Dimond Park Pathways Accessibility Evaluation

Prepared for: The City of Oakland, ADA Programs Division

DIMOND PARK PATHWAYS ACCESSIBILITY EVALUATION

1. Stair treads need to be reconstructed.

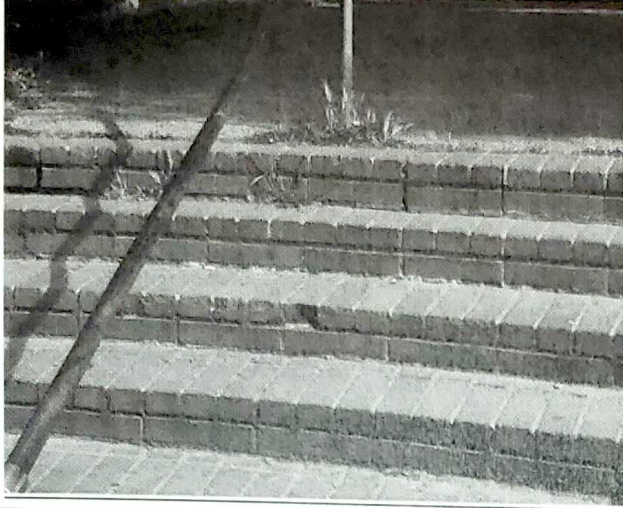
- A. Several of the existing red brick stair treads that require repairs. These stair treads need to be reconstructed. See photo #1.
- B. The stairs need to have handrails installed at the center of each stair case. See photos #2 and #3.

2. Edge of stair treads need contrasting color.

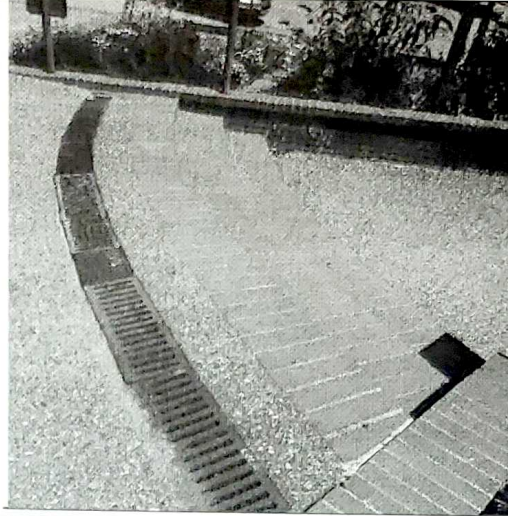
- C. The edge of each stair tread needs to be delineated with a contrasting color. See photo #2.
- D. The trench drain grates in the vicinity of the stairs need to be replaced with ADA compliant grates. See photos #2 and #5.

4. Accommodate bicyclists that wish to bypass the stairs.

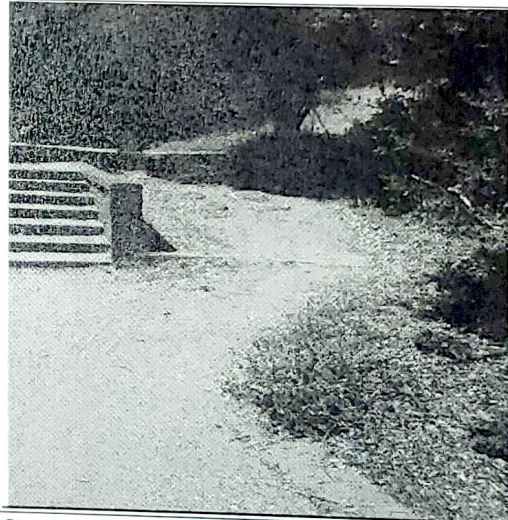
- E. Improvements should be made to accommodate bicyclists that wish to bypass the stairs. A new compacted gravel pathway should be constructed northerly of the stairs. See photo #4.

8. Crossing at Fruitvale.

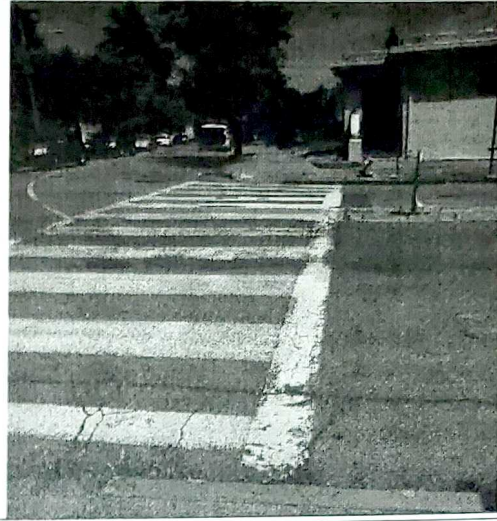
- G. The curb ramps at the intersection of Fruitvale Avenue and Lyman Road should be field surveyed and modified to be in compliance with current curb ramp requirements. See photos #7, #8, #9 and #10.

21. Existing disabled parking stalls at west entrance of Dimond Park.

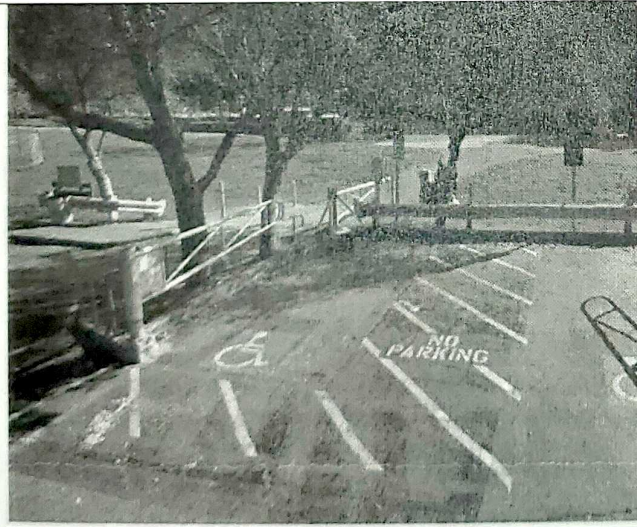
1. The City ADA Coordinator and Dimond Recreation Center Director reported that community stakeholders have requested that two of the existing general 90-degree parking stalls be converted to Disabled Parking stalls. See photo #23.
2. It appears additional roadway and/or ramp improvements are needed to accommodate persons with disabilities. Field surveys should be performed to evaluate the accessible route to/from the Disables Parking stalls to/from Dimond Park. See photos #21 and #22.
3. Disabled Parking stall pavement markings, striping and signage should be evaluated to ensure compliance with existing requirements. At a minimum, pavement markings should be reapplied. See photos #21, #22 and #23.
